STATE OF VERMONT
AGENCY OF TRANSPORTATION

PROPOSED IMPROVEMENT
BRIDGE PROJECT
TOWN OF BRATTLEBORO
COUNTY OF WINDHAM

ROUTE NO : US 5 (T.H.1) BRIDGE NO : 7

RECORD PLANS

ABUTMENT NO. 1 ELEVATION

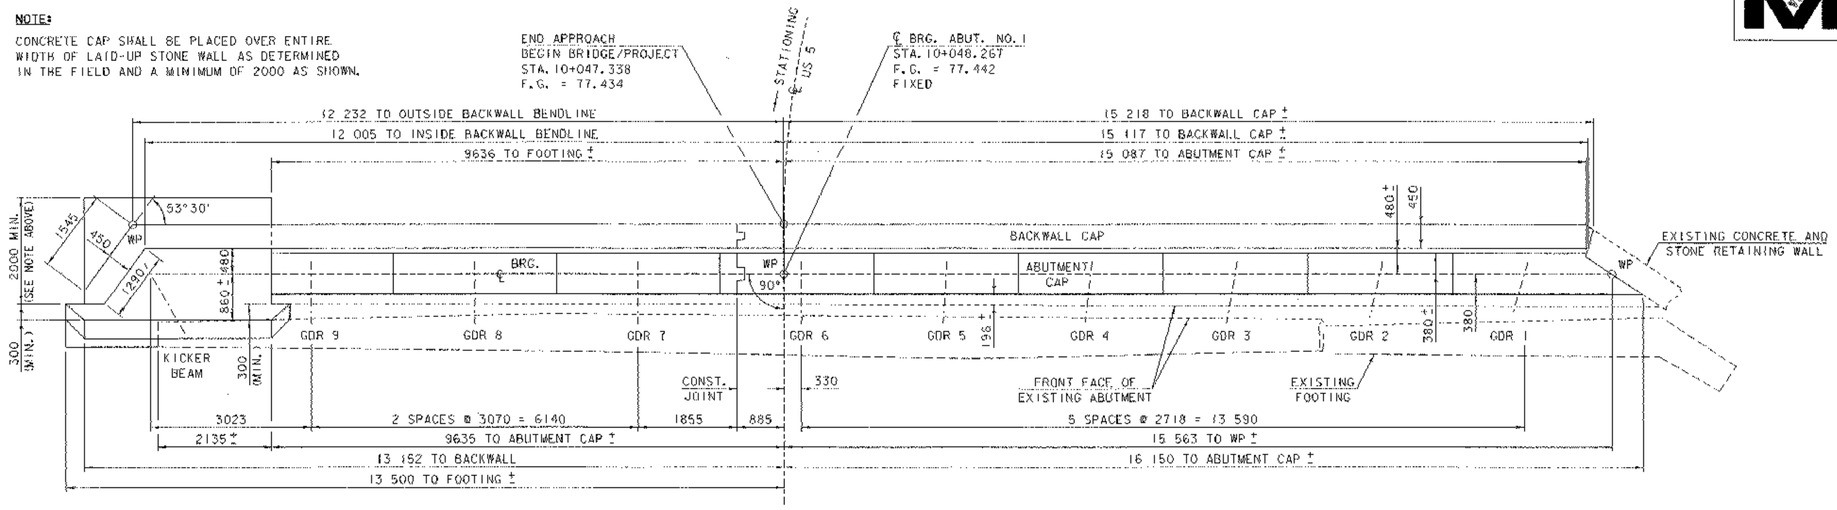
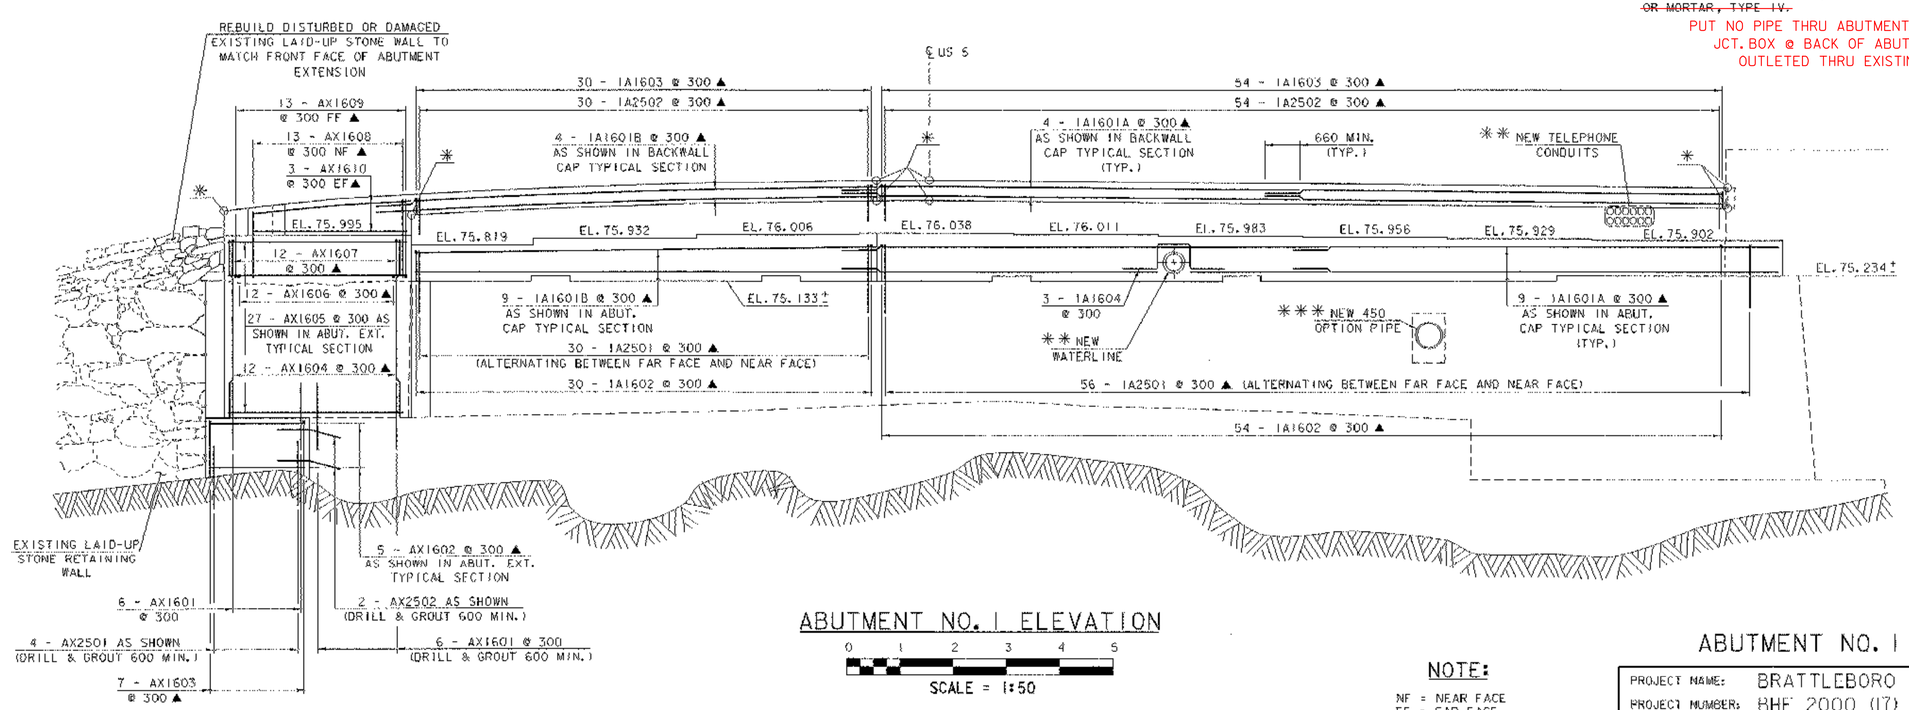
PUT NO PIPE THRU ABUTMENT, BUILT 4' x 4' JCT. BOX @ BACK OF ABUTMENT THAT OUTLETED THRU EXISTING HOLE

PLAN VIEW
1" = 40'

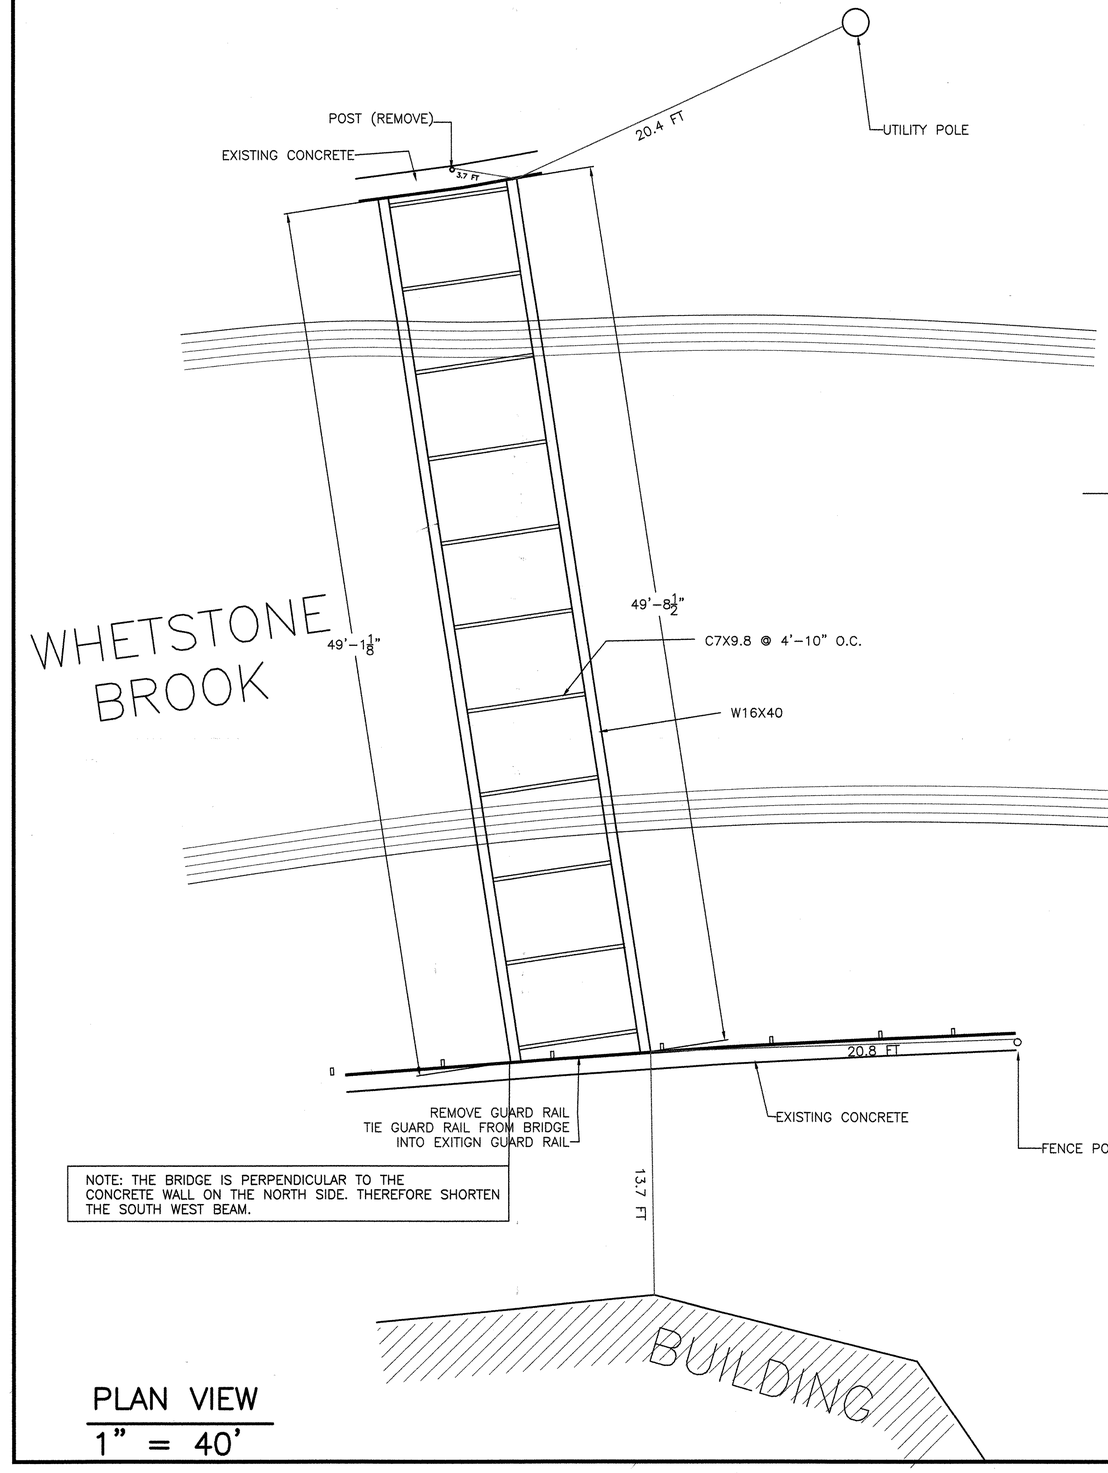
NOTE: THE BRIDGE IS PERPENDICULAR TO THE CONCRETE WALL ON THE NORTH SIDE. THEREFORE SHORTEN THE SOUTH WEST BEAM.

EXPANSION BEARING DETAIL- ABUTMENT NO. 2

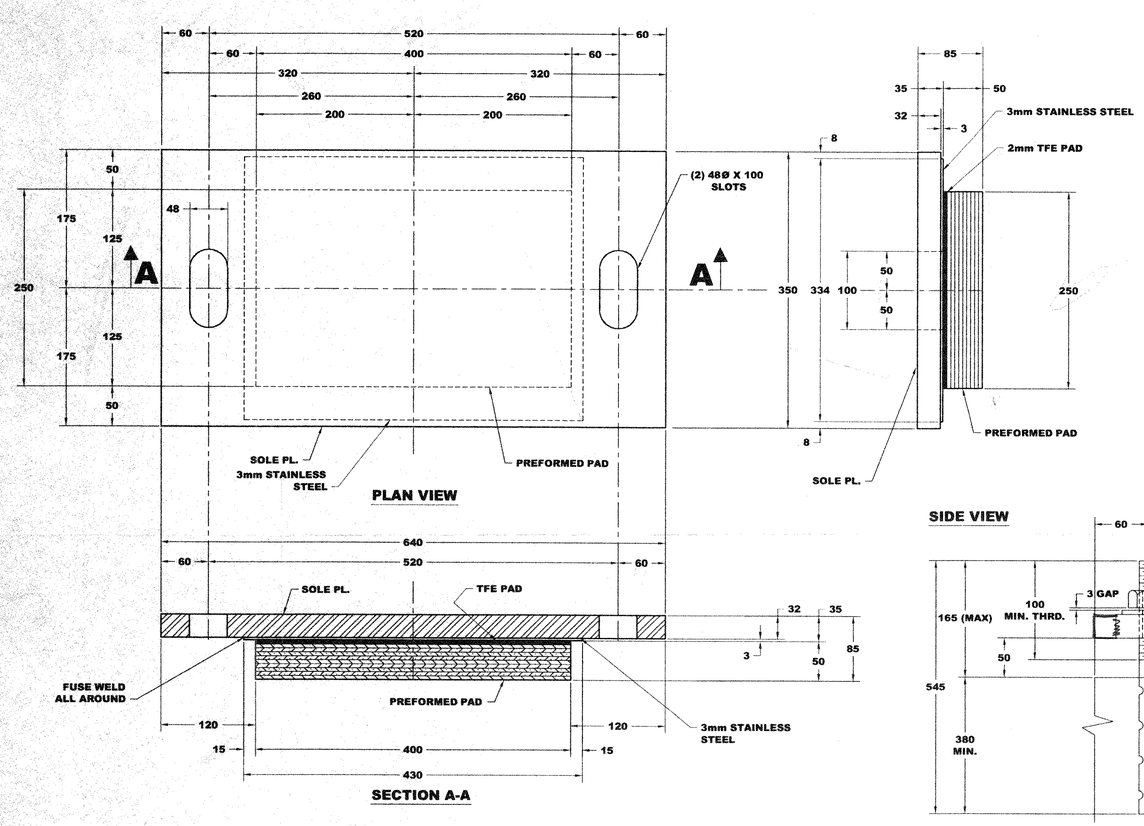
Add same notes as sheet 1 plus: "The surface finish of the contact (sliding) face shall have a mirror finish as per spec. 731.05."
